Drawn By: XYLiu	Checked:	Approved:	Model No: #91443 RX 49.860MHz
Date: 2006/04/12	Version: 0.1	Sheet: 1 of 1	Ref No:

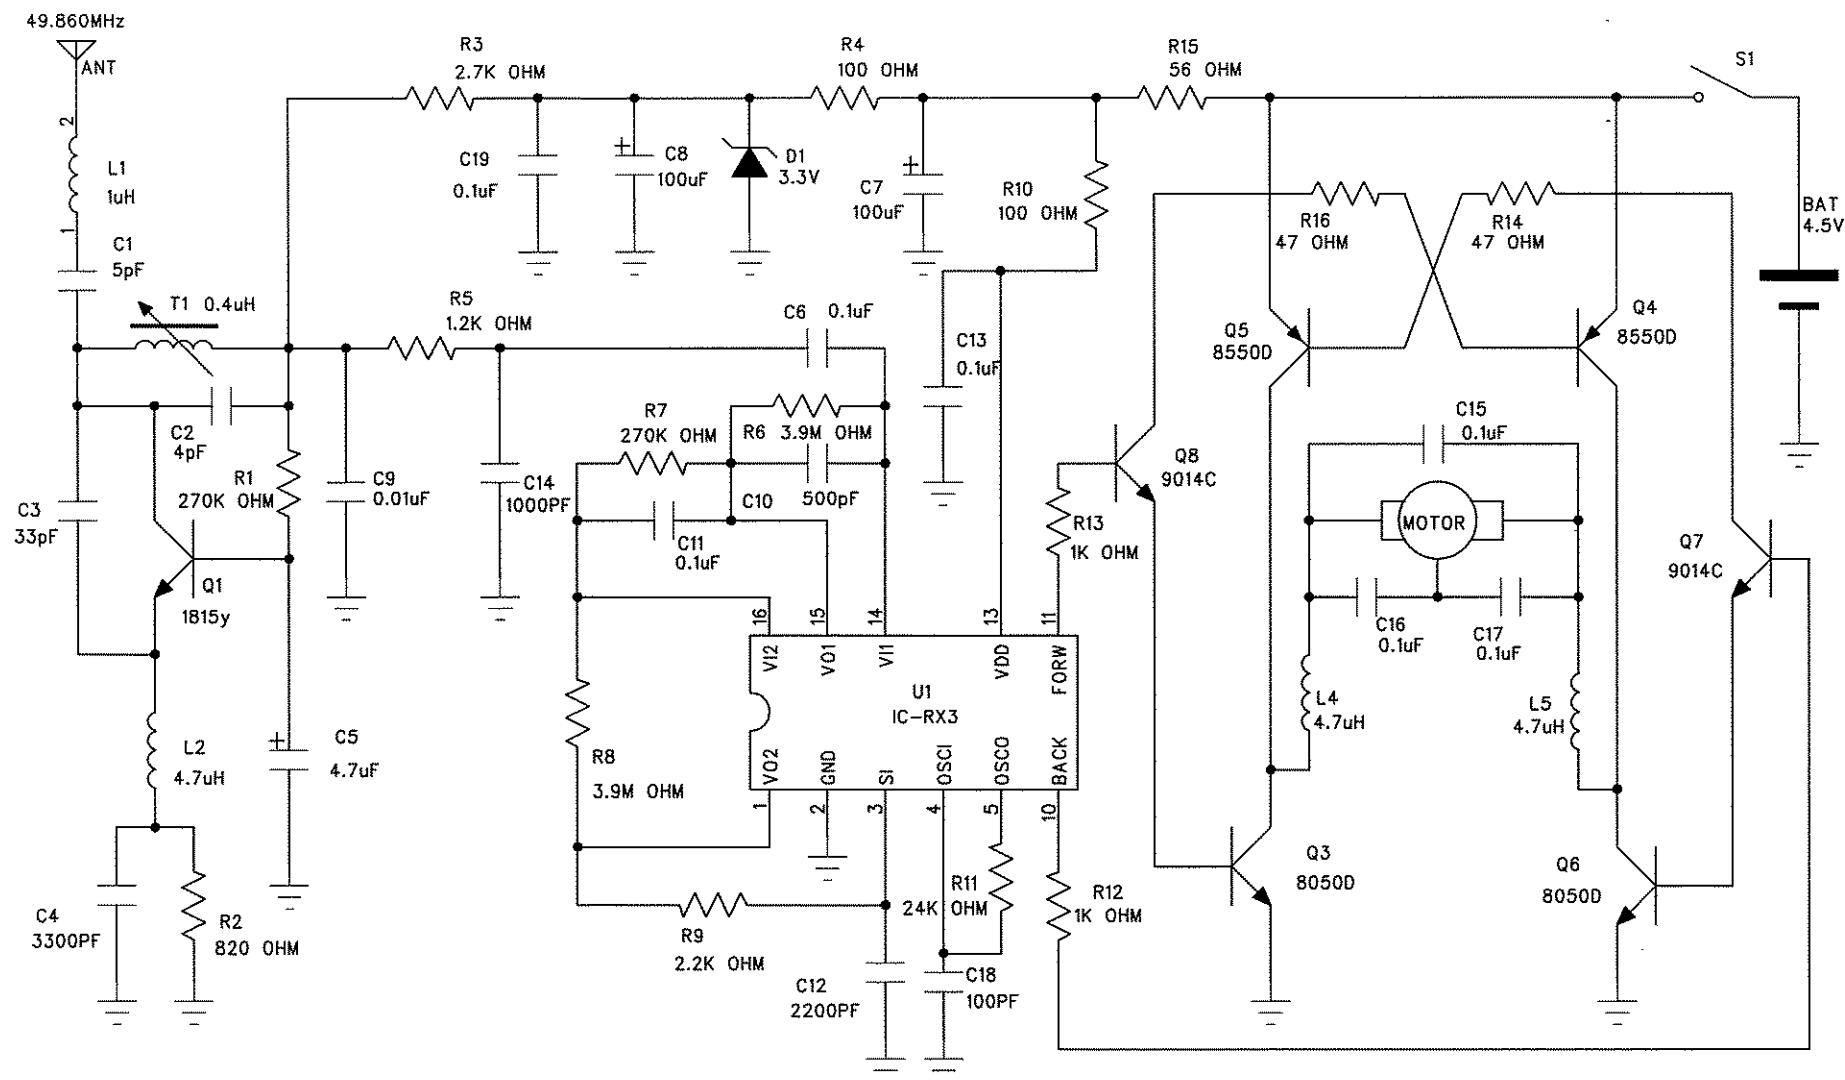
Issue	Zone	Description	Date
V01	R1	R1=120K OHM change to 270K OHM	APR12
	R3	R3=2.2K OHM change to 2.7K OHM	APR12
